Planning Commission Staff Report

July 13, 2016
Item 6.b.

SUBJECT: PUD-118

LOCATION: 4791 Augustine Street

Figure 5: Mixed-Use Building

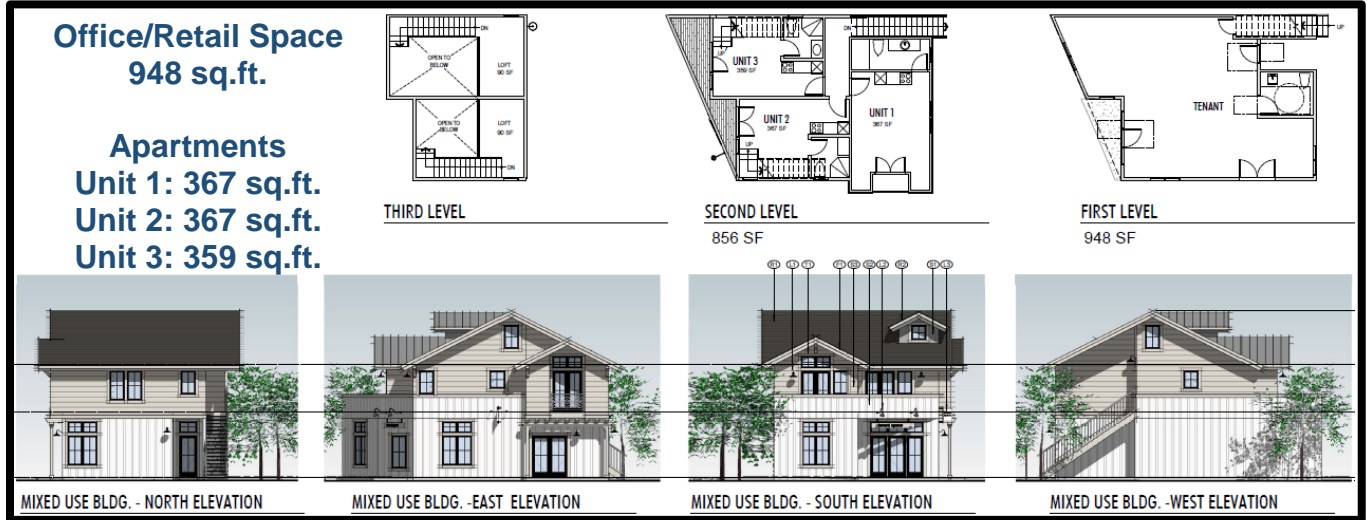
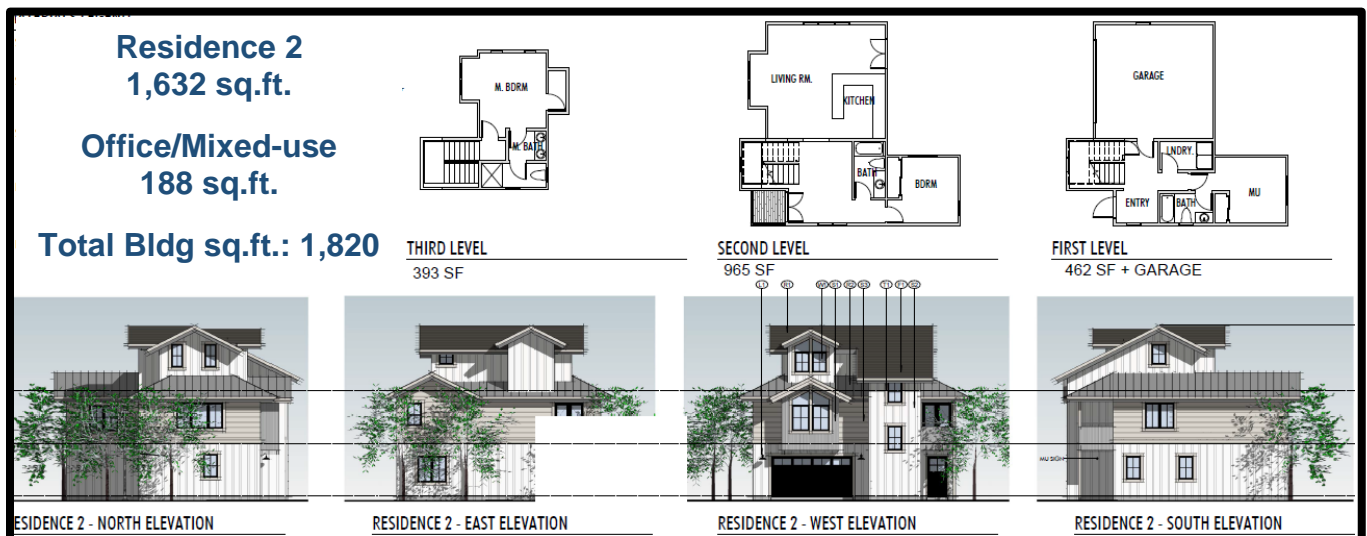
The mixed-use building would provide an at-grade entrance to the office/retail space and provide display windows that would provide a pedestrian friendly storefront element. The storefront windows and the use of a variety of façade materials, including stucco, wood, and metal would add to the architectural variety of the Downtown.

Figure 7: Staff’s Recommended Changes to Residence 1

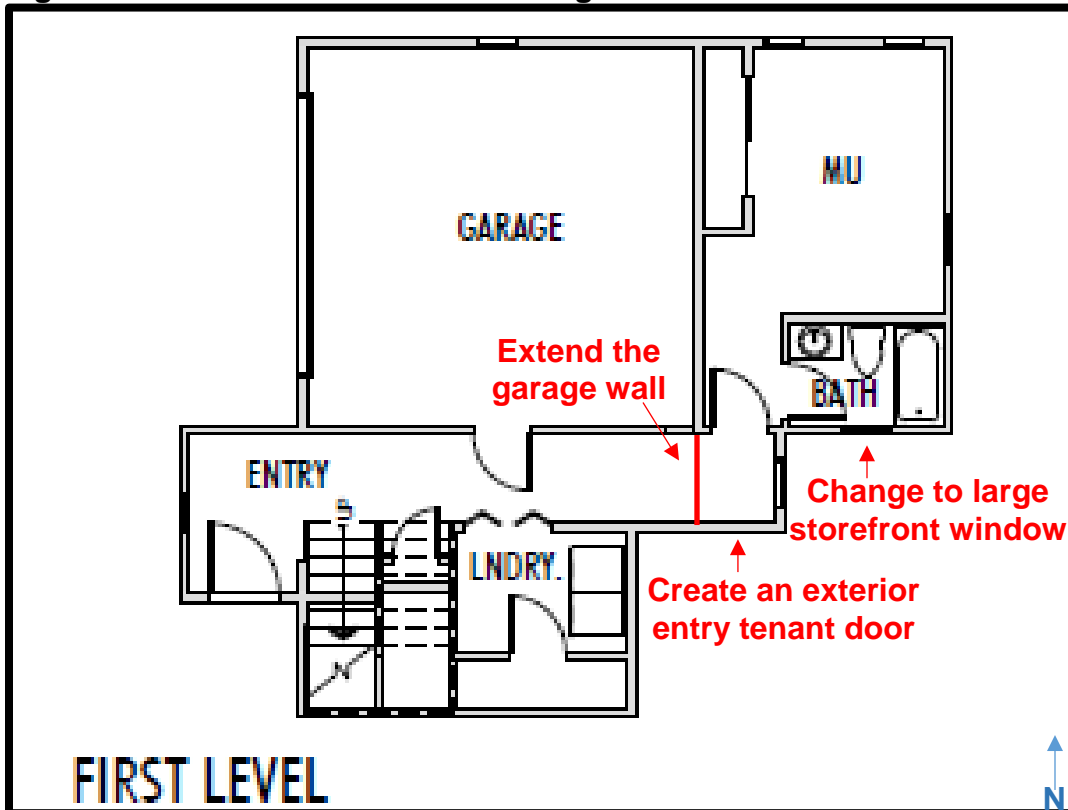
In the current plans, the applicant has identified potential “mixed-use” space that could be used as a bedroom or an office space on the ground floor of each single-family residential unit. Staff is not opposed to the potential office space in each detached unit, but is skeptical that this space would be used in a way that would meet the intent of the Office district. It is likely that the flexible “mixed-use” spaces would be used as bedrooms, similar to other residential units with multiple bedrooms, as the mixed-use spaces would not be accessed via an independent doorway and would not have design features (substantial windows) that would make the spaces attractive to office tenants. Staff believes the project would be consistent with the Specific Plan and General Plan land use designations if Residence 1 was designed such that the first-floor mixed-use (MU) space is identified for office/retail uses and separated from the residential unit and the south elevation of Residence 1 is designed such that it has an office/retail appearance. This can be achieved by extending the south garage wall adjacent to the MU space to the entry hallway in front of the unit’s laundry room and creating an exterior

tenant-access-only door on the west elevation. Large storefront windows, similar to those of the dedicated mixed-use building, should be utilized in the south elevation to delineate the space from the residential unit. Please see Figures 7-9. These changes would create a project with continuous office/retail frontage on Old Bernal Avenue with residential space above or behind office/retail space. Staff notes that the office/retail spaces would be required to meet applicable Americans with Disabilities Act (ADA) requirements (e.g., ADA-compliant restrooms would be required). A condition of approval has been recommended that summarizes the staff recommendation.
